Date of Application: 4/19/2023

SUBJECT: Preliminary Site Plan and Design review for 40 Residential Units 2306 Fillmore Street.

PROPOSED 39 UNITS
MULTI-FAMILY
DEVELOPMENT FOR:
2306 FILLMORE STREET
HOLLYWOOD FL

TD-1

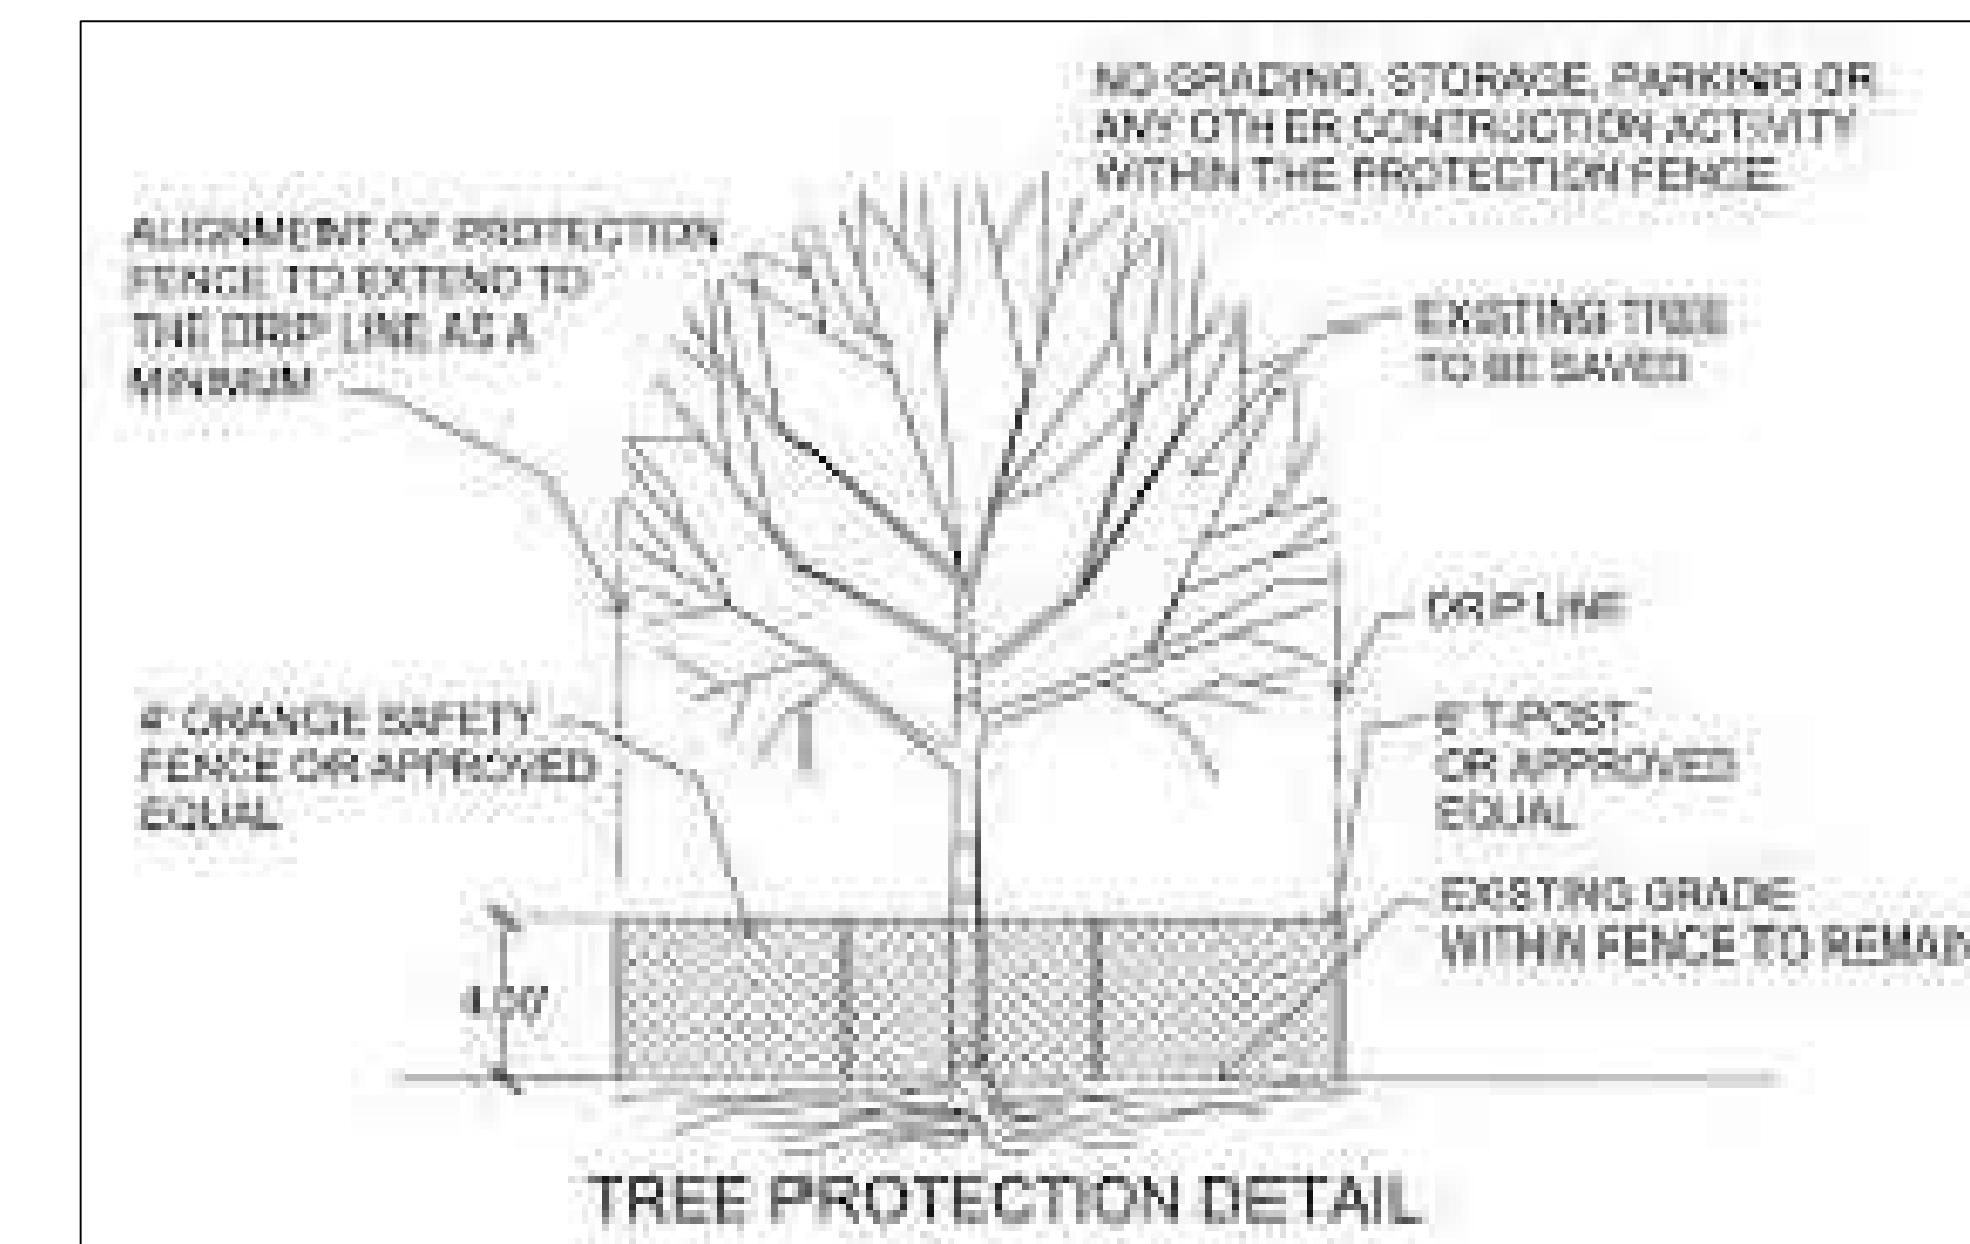
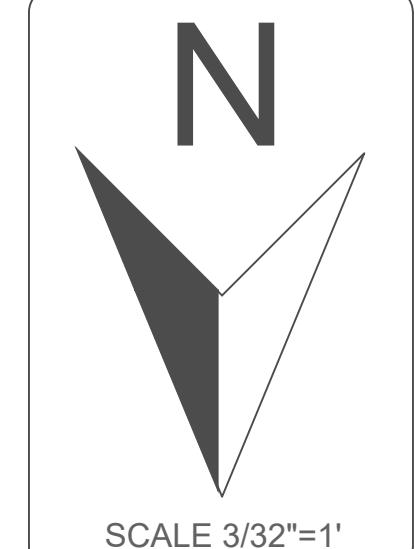
2. Revise tree disposition, Norfolk island pine is a nuisance tree and exempted from mitigation.

3. Show city approved protection detail with orange mesh.
Response: Orange mesh tree protection has been added. See TD-1 with revision cloud.
4. North arrow points to wrong direction on plans.

Response: Norfolk Island Pine has been removed from mitigation. See TD-1 with revision cloud.

L-1

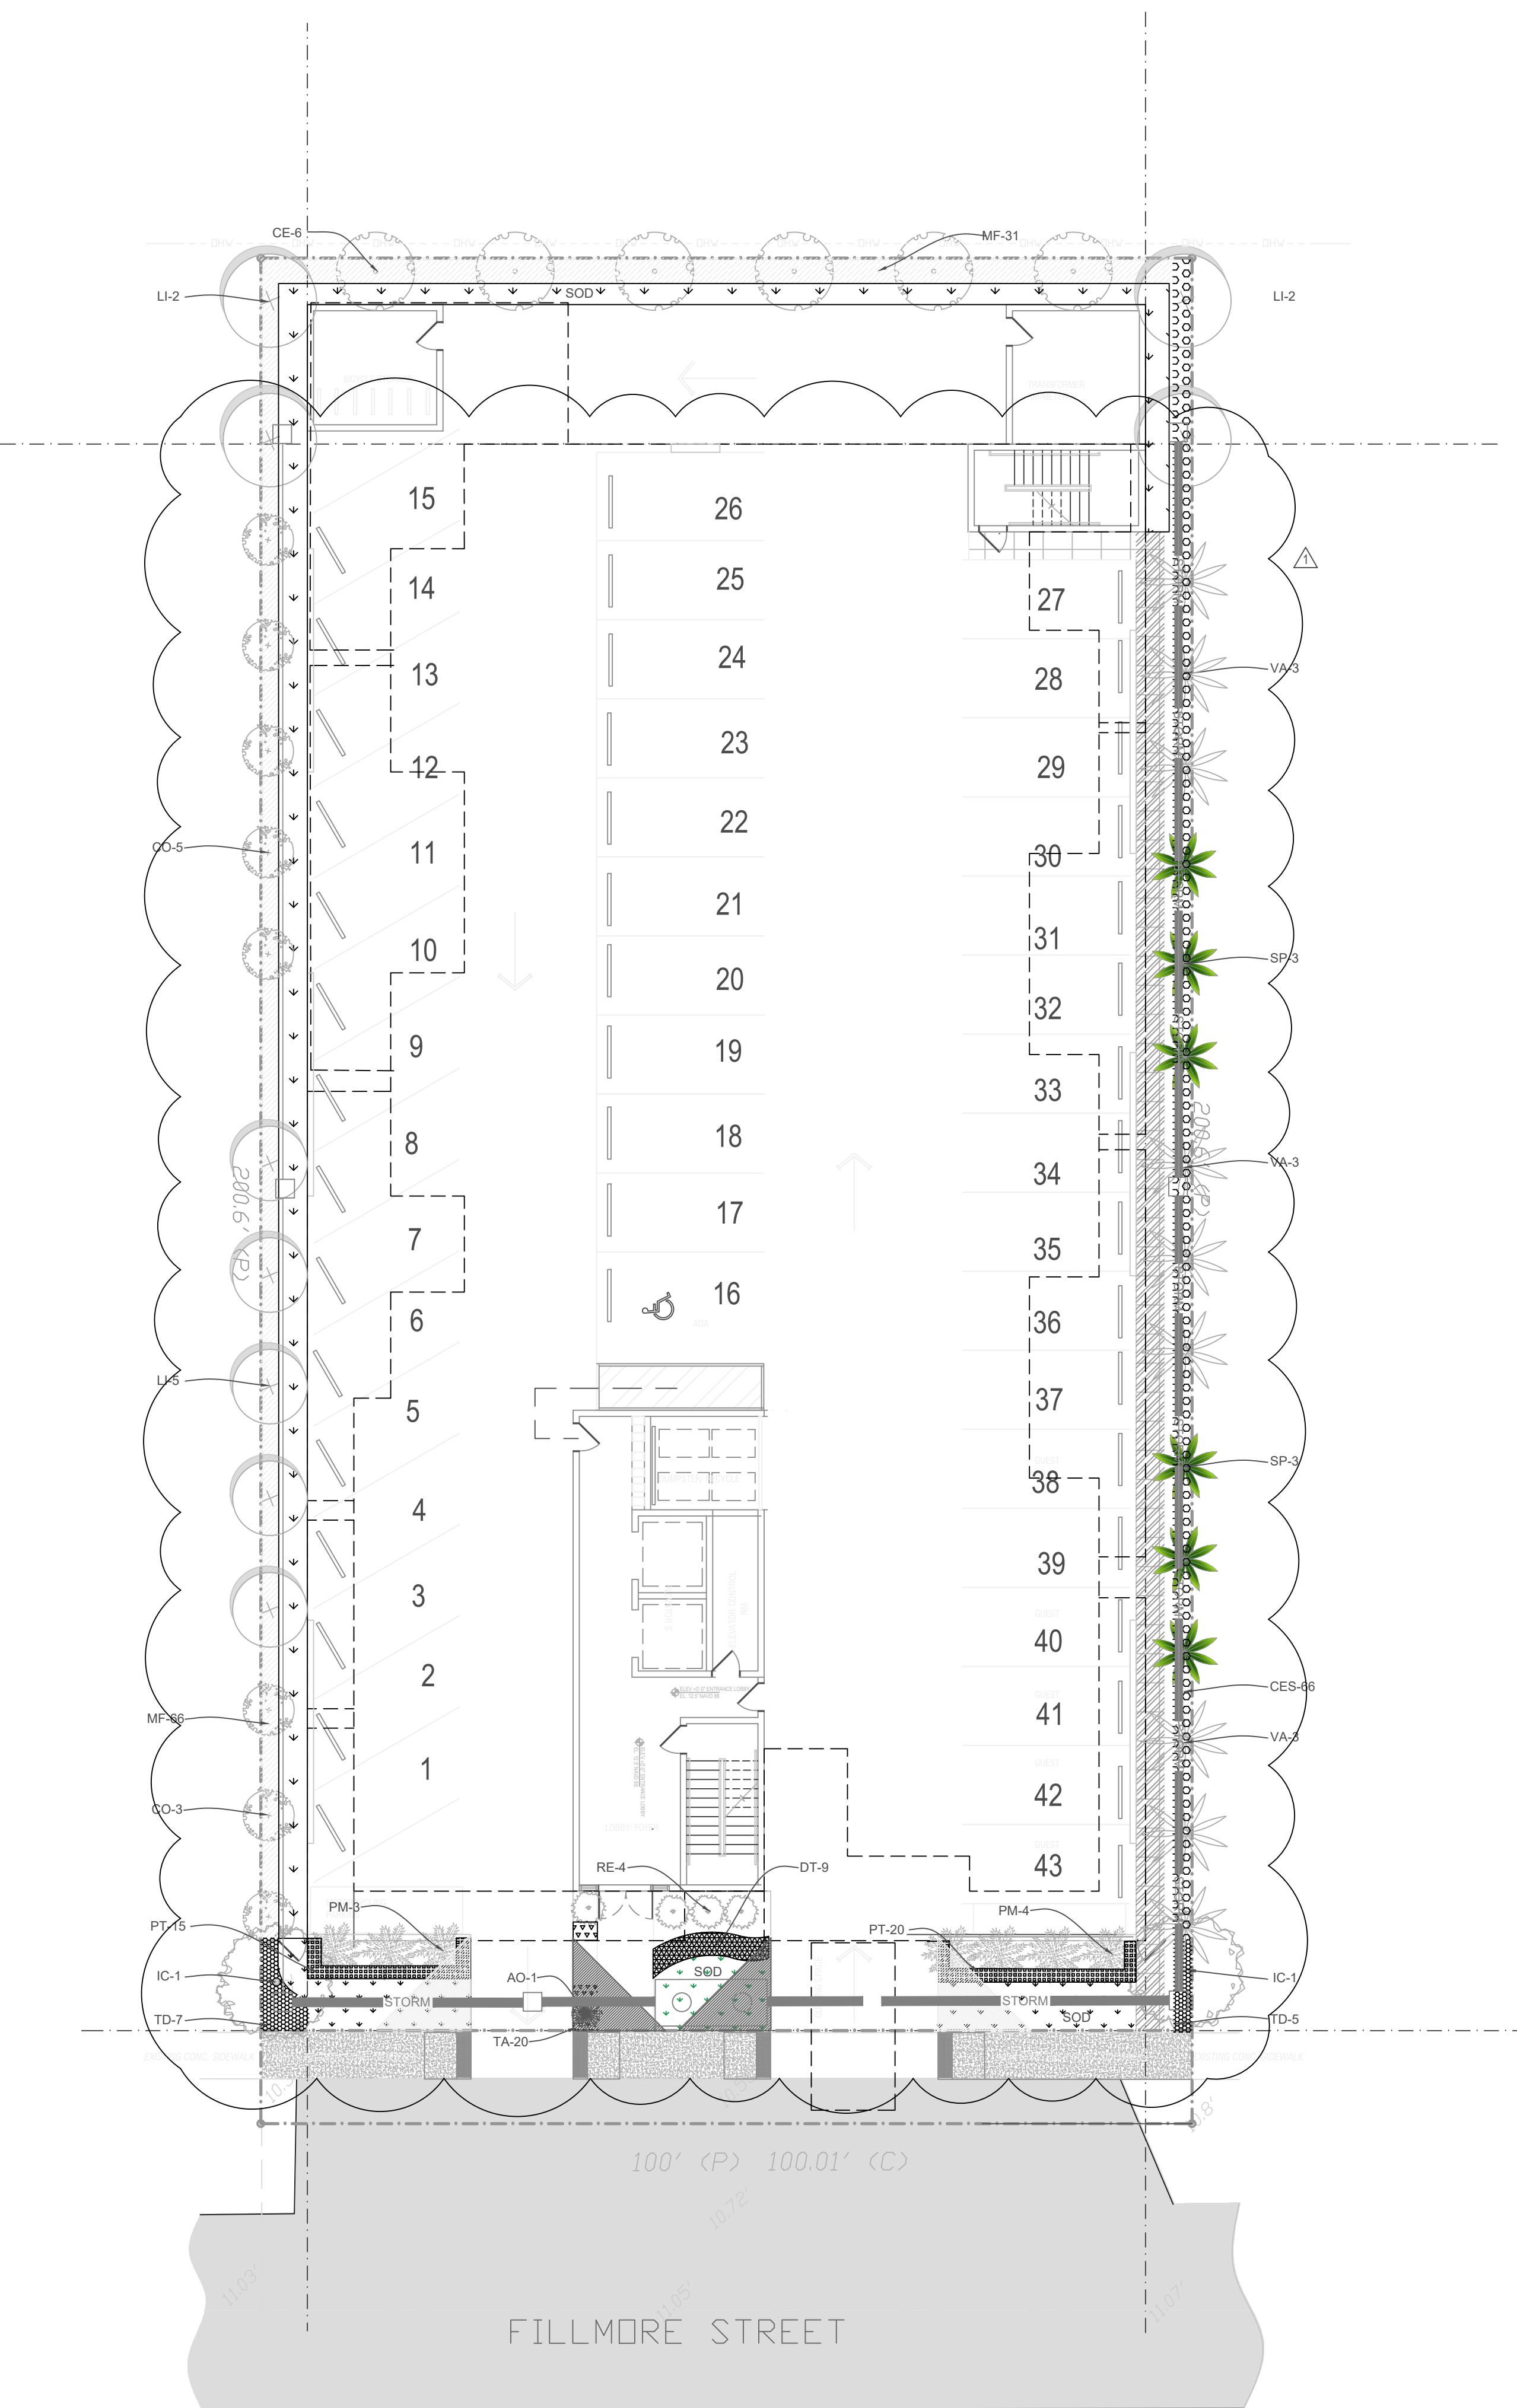
6. Provide 24x36 PDF sheets on next submittal as the ones submitted are smaller than the rest of the project set.
Response: All sheets are 24" x 36" .
7. Landscape data chart says: Single-Family requirements. Revise as per project zoning.

Response: Single family has been removed from site calculations chart. SEE L-1 with revision cloud.
8. Revise mitigation calculations as needed and add details of which trees/palms are being used to satisfy the mitigation.
